**30-039-23212 JICARILLA 362 GD #003**

**DJR OPERATING, LLC**

DJR Operating, LLC requests permission to Plug & Abandon the subject well per the attached Procedure, Wellbore Diagram, and Reclamation Plan.

**CONDITIONS OF APPROVAL**

## Wellbore Diagram

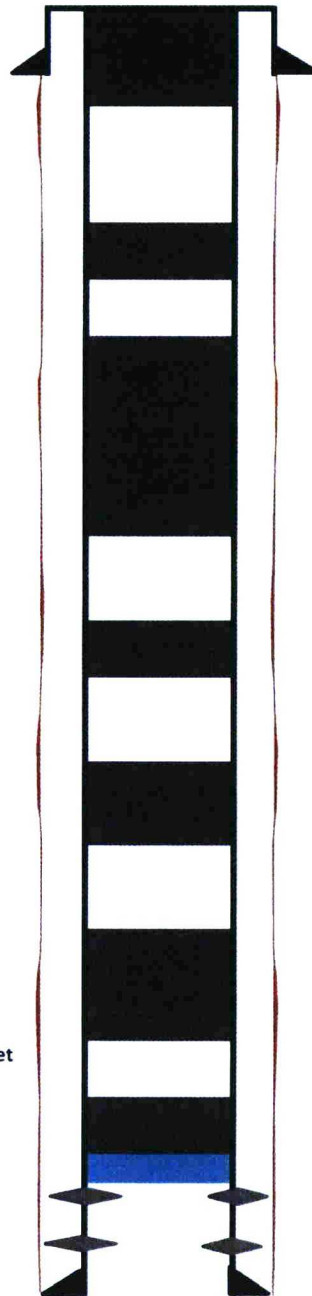
- Notify NMOCD 24hrs prior to beginning operations..
- Extend plug #6 to 775' – 600' to cover the Nacimiento top. OCD Nacimiento pick @ 725'.

1. Plugging operations authorized are subject to the attached "General Requirements for Permanent Abandonment of Wells on Federal and Indian Lease."
2. Farmington Office is to be notified at least 24 hours before the plugging operations commence (505) 564-7750.
3. Submit electronic copy of the CBL for verification to the following addresses: [jkillins@blm.gov](mailto:jkillins@blm.gov) , [jhoffman@blm.gov](mailto:jhoffman@blm.gov) and [Brandon.Powell@state.nm.us](mailto:Brandon.Powell@state.nm.us) . Based on CBL results inside/outside plugs and volumes will be adjusted accordingly. Please review the General Requirements document to ensure volumes meet required excess inside and outside casing.
4. Modify plug 4: BLM picks top of Chacra 3480' md. Adjust plug to cover (3430 – 3530' md)
5. Modify plug 6: BLM picks top of Nacimiento 650' md. Adjust plug to cover (600' – 700' md)
